Replacing an Existing HH or IH Pod Drive with a Zeus 3000 Series Pod (KP) Drive

Revised September 2017. This bulletin supersedes the previous bulletin number 2009-70R1 November 2009.

a - Seacock—HH and IH
b - Seacock—3000 Series

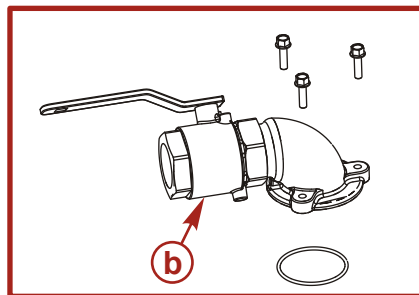
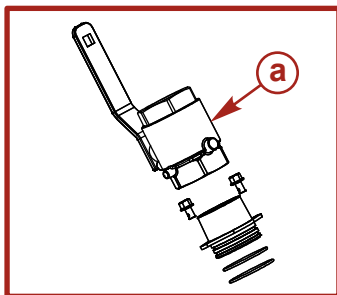
- The seacock on the 3000 Series pod drive is not interchangeable with earlier HH and IH model seacocks. The new seacock must be ordered from Mercury Marine and must be installed after the drive is in the boat and the clamp ring is installed. The new seacock mounts to either the port or starboard side of the drive. The part numbers for the seacocks are:

Description	Part Number
51 mm (2 in.) seacock	879150A63
64 mm (2-1/2 in.) seacock	879150A64

3000 Series Pod drive cover changes

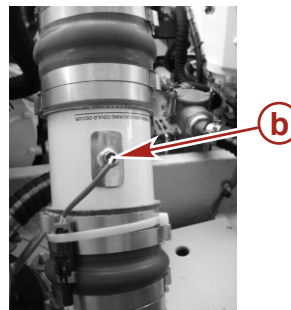
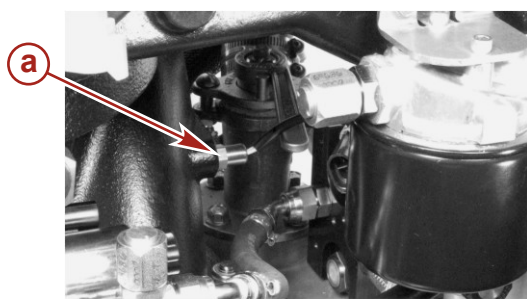
- The drive cover (shroud) from an IH model will fit on a 3000 Series pod drive model, except those models equipped with a cold water cooler. The IH cover blocks some of the service access points on the 3000 Series pod drive. Changing the cover to a new 3000 Series cover will provide proper service access and will fit models with a cold water cooler. The new covers can be ordered from Mercury Marine.

Description	Part Number
Zeus 3000 Series pod drive cover kit	879150A70

Exhaust temperature sensor relocation

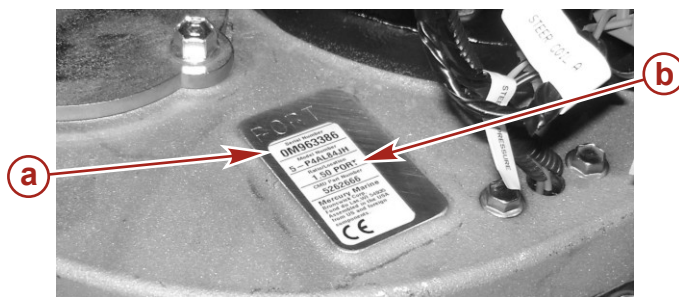
- The exhaust temperature sensor is not mounted on the 3000 Series pod drive. The exhaust temperature sensor on the HH and IH pod has been relocated to the engine exhaust. Contact Mercury Diesel Technical Service if the exhaust temperature sensor is mounted on the steering actuator of an existing pod.

TVM Replacement

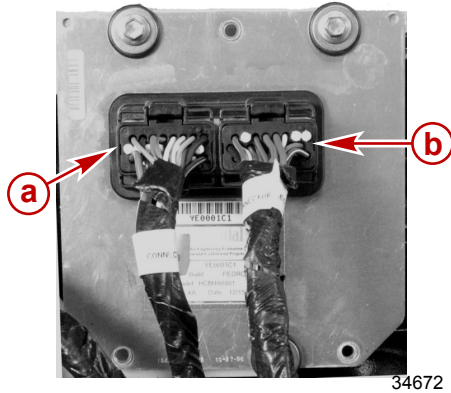
Zeus IH and HH pods can be replaced with the new KP pods. However, both pods must have valid software level combinations. If both IH and HH pods are being replaced, no special actions are required to make them compatible with the vessel. However, if only one pod is replaced with a KP model pod then: you must replace the TVM and five hydraulic transducers from the new KP pod with a TVM and the hydraulic transducers listed below.

1. Unlock and disconnect the two TVM connectors.

2. Remove the two upper screws and washers and remove the TVM by lifting it up and out.
3. Remove and retain the two upper grommets.
4. Install the two upper grommets on the new TVM module.
5. Mount the TVM to the electrical bracket by sliding the slot at the bottom of the TVM into the lower grommet.
6. Install and tighten the two upper TVM mounting screws to the specified torque.

Description	Nm	lb-in.	lb-ft
TVM mounting screws	5.5	48.7	-

7. Attach the TVM connectors A and B. The wires are tagged connector A and connector B. Ensure that the connectors lock.

Hydraulic Transducer Replacement

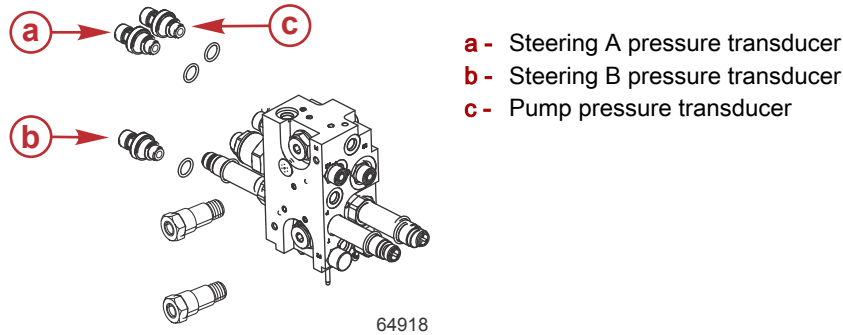
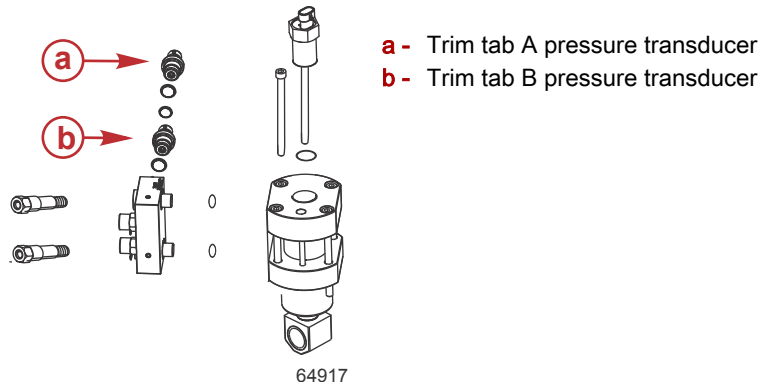
Each KP pod's hydraulic steering manifold contains three pressure transducers. These steering pressure transducers are indicated by letters a, b, and c in the following illustration.

Each KP pod's hydraulic trim tab manifold contains two pressure transducers. These trim tab pressure transducers are indicated by the letters a and b in the following illustration.

Qty.	Description	Nm	lb-in.	lb-ft	Part Number
5	Hydraulic pressure transducer	25	-	18.4	8M6001284
